**State Project No. 052-0076N  
Farmington High School  
Recommendation for Change Order**

# Proposed Change Order

**Project:** Farmington High School and Central Office Renovation

**Change No.:** PCO 007

**SINGLE LINE DIAGRAM - ELECTRICAL**

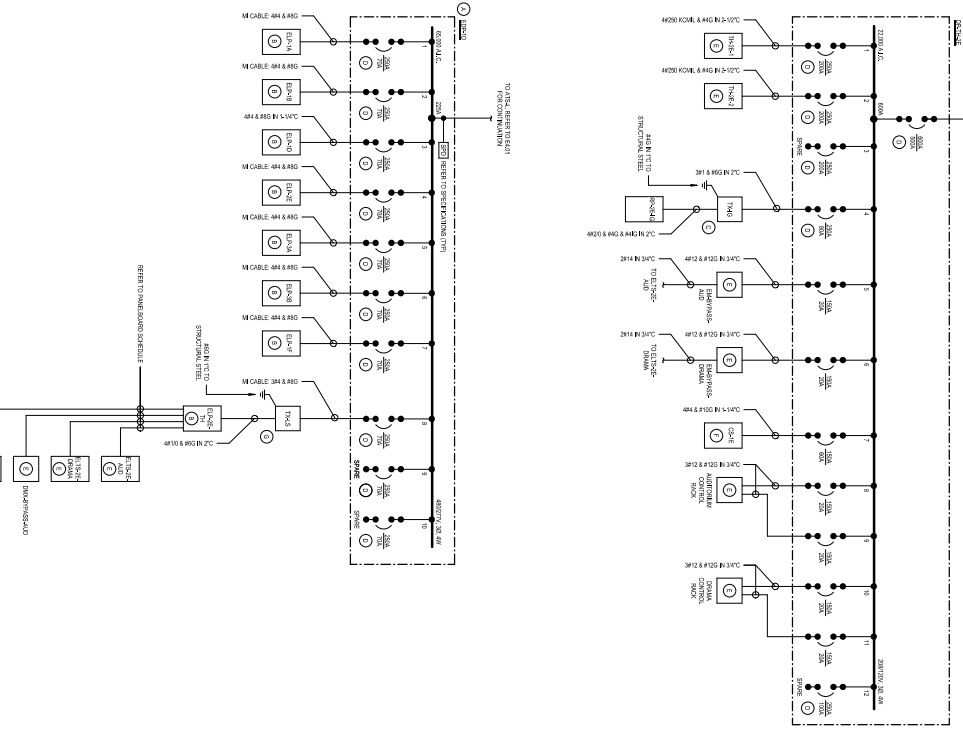
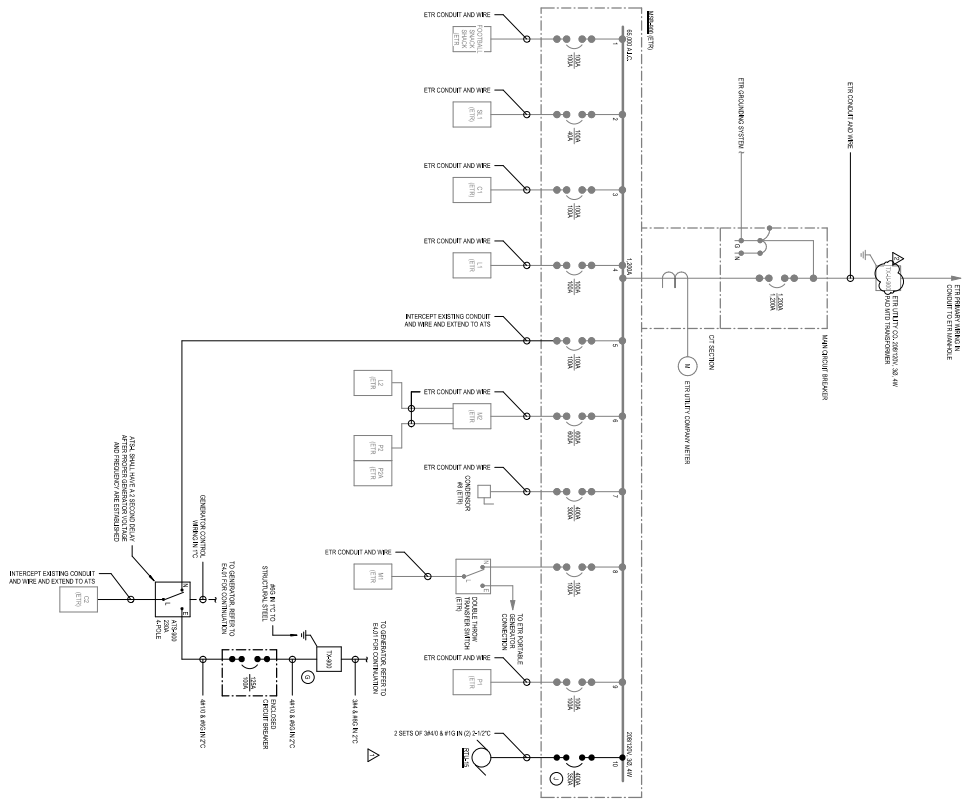
Following are revised drawings to accommodate Eversource revisions to primary routing. Also included in this PR revision is fiber conduit requested by the School
